IN THE UNITED STATES PATENT AND TRADEMARK OFFICE

In re Application of: Nancy C. Frye
Serial No.: 10/790,923
Filing Date: March 1, 2004
Confirmation No.: 1435
Group Art Unit: 3728
Examiner: Marie D. Patterson
Title: SHOE AND LAST

PETITION TO REVIEW EXAMINER'S HOLDING OF NEW MATTER

**FIG. 12****FIG. 14**

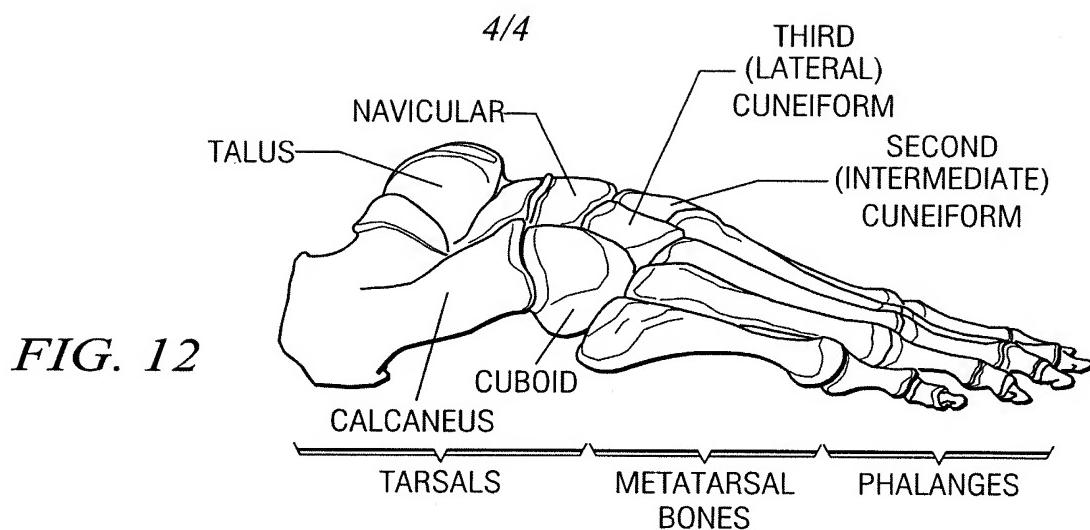
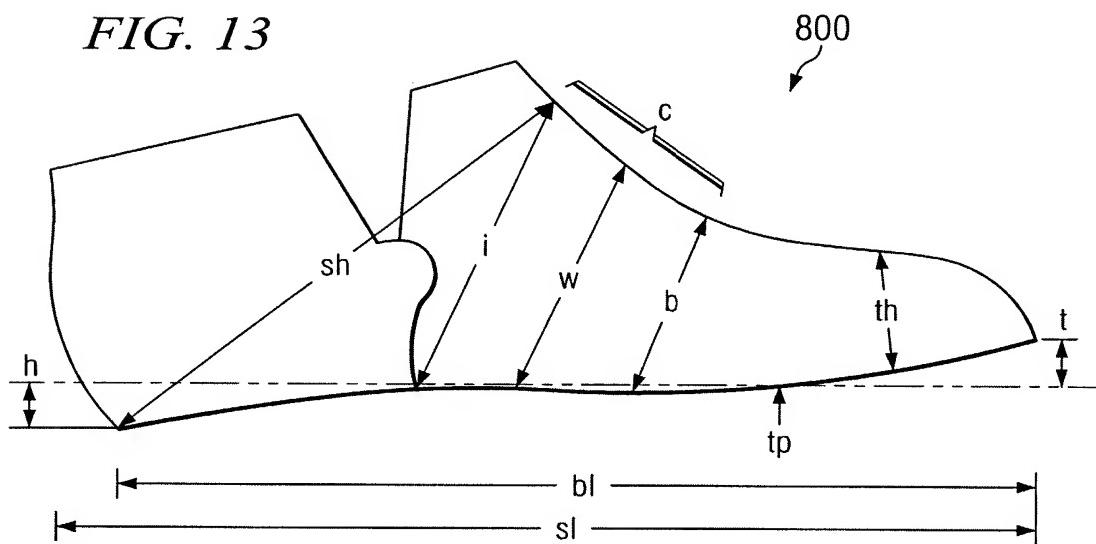
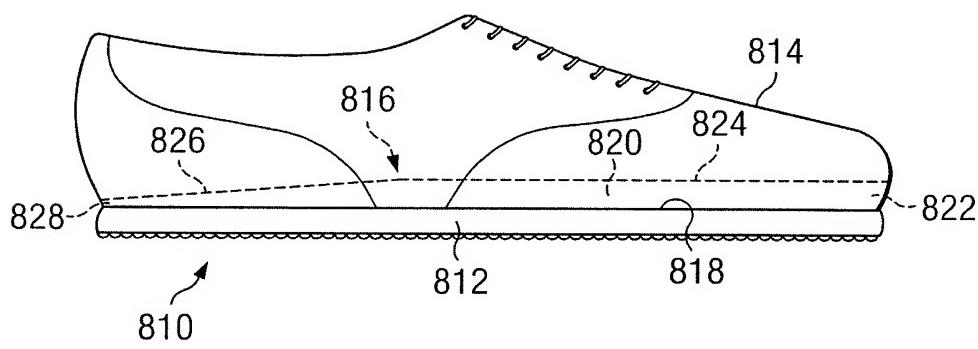
The drawings stand objected to under 37 C.F.R. §1.83(a) as not showing every feature of the invention specified in the claims. Attached herewith is a Replacement Sheet showing changes made to FIGURE 14 addressing matters raised by the Examiner. The Examiner has stated that the changes to FIGURE 14 present new matter. For reference, also attached herewith is a copy of original FIGURE 14. The feature of Claims 8, 9, 16, and 20 indicated by the Examiner as not being shown in the drawings is a midsole. FIGURE 14 has been amended to include a midsole 829 as requested by the Examiner. Applicant's specification discloses a midsole that is a feature of Claims 8, 9, 16, and 20. Support for the thickness, shape, and exact location for a midsole is provided in Applicant's specification at page 22, lines 7-12, and page 29, lines 11-13. No unusual details have been added to FIGURE 14 with the inclusion of the midsole. The Examiner's holding of new matter has no merit as a midsole and its form are explicitly disclosed in Applicant's specification and merely inadvertently not shown in the original drawings. The Examiner's position seems to be that no changes whatsoever can be made to the drawings after filing. This position is not justifiable as the M.P.E.P. clearly allows for changes to the drawings if there is support elsewhere in the Application. See M.P.E.P. §§ 608.04, 608.01(l), and 706.03(o). Therefore,

The drawings stand objected to for being inconsistent with Applicant's specification. The Examiner indicates that moving reference numeral 824 to any other location in FIGURE 14 is new matter. Applicant's specification discloses that a point 824 is approximately halfway across a length of shoe 810 that is also a feature of Independent Claims 1, 11, and 16. FIGURE 14 has been amended to show that point 824 is substantially halfway across a length of the shoe as requested by the Examiner. Applicant's specification discloses the location of point 824 at page 29, lines 16-20. No unusual details have been added to FIGURE 14 with the inclusion of the midsole. The Examiner's holding of new matter has no merit as the location of point 824 is explicitly disclosed in Applicant's specification and merely inadvertently not shown in the corrected location in the original drawings. The Examiner's position seems to be that no changes whatsoever can be made to the drawings after filing. This position is not justifiable as the M.P.E.P. clearly allows for changes to the drawings if there is support elsewhere in the Application. See M.P.E.P. §§ 608.04, 608.01(l), and 706.03(o). Therefore, Applicant respectfully submits that the drawings are in compliance with 37 C.F.R. §1.83(a).

Applicant respectfully submits that the drawings are in compliance with 37 C.F.R. §1.83(a) and no new matter has been added to the Application with the inclusion of the midsole to FIGURE 14.

In light of these considerations, Applicant respectfully submits that entry of the Replacement Sheet with changes to FIGURE 14 is appropriate and does not present new matter.
